Mercedes-Benz

Campaign No. 2015020001, February 2015

SUBJECT: **Models 212 (E-Class), 218 (CLS-Class), Model Years 2013-2015
Secondary Rubber Hood Seal, Model 212 (E-Class)**

Figure 1

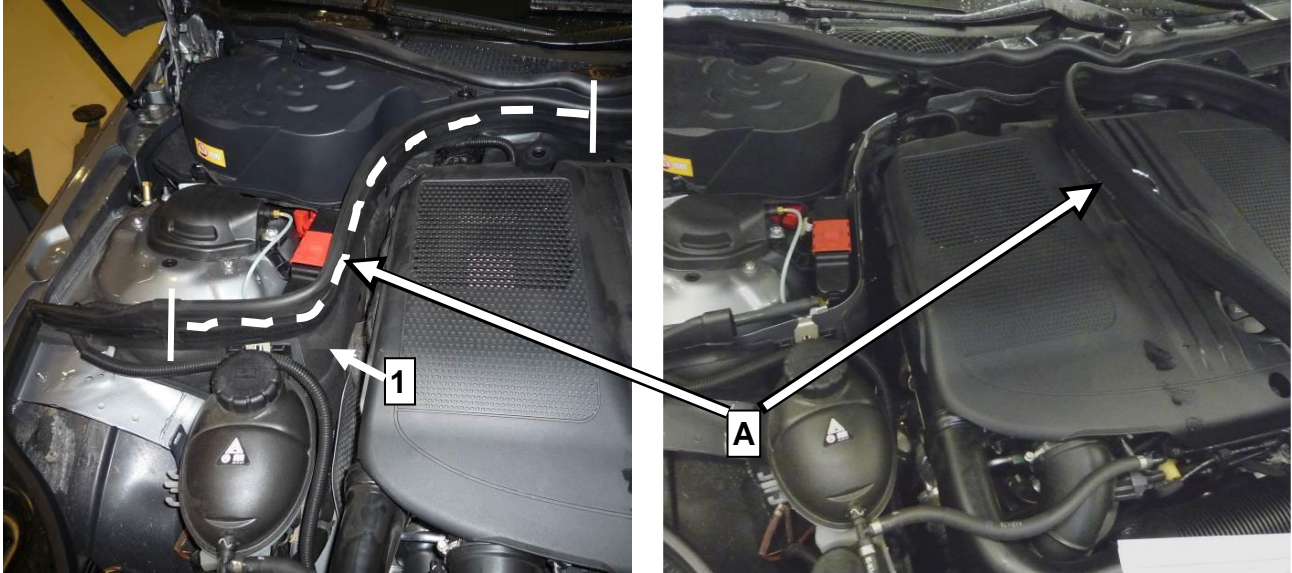
1.  Open hood then loosen approx. 0.5 m of edge guard (A, Figure 1) from the right side of secondary engine bulkhead (1) and place to one side.

3.  Reinstall edge guard (A, Figure 1) onto upper edge of bulkhead (1).

Edge guard (A) must be installed firmly on the secondary bulkhead (1) edge.

Figure 2

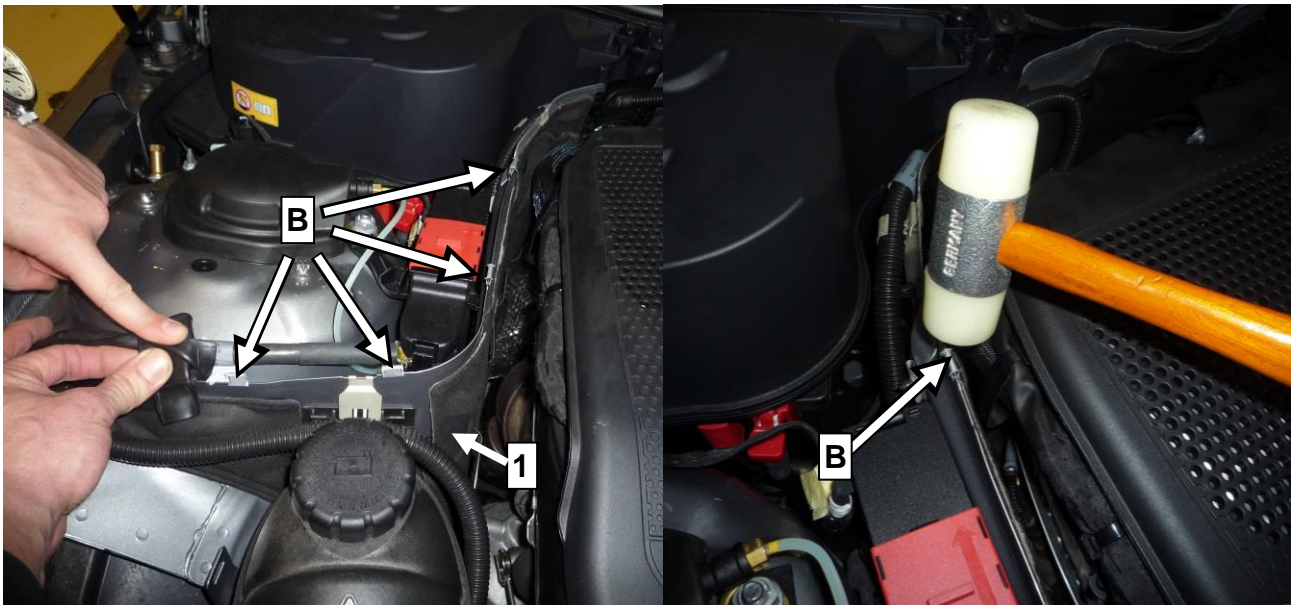
2.  Install 4 retaining clips (B, Figure 2) as shown then hammer clips (B) onto upper edge of secondary bulkhead (1) until they are seated on the bulkhead (1).
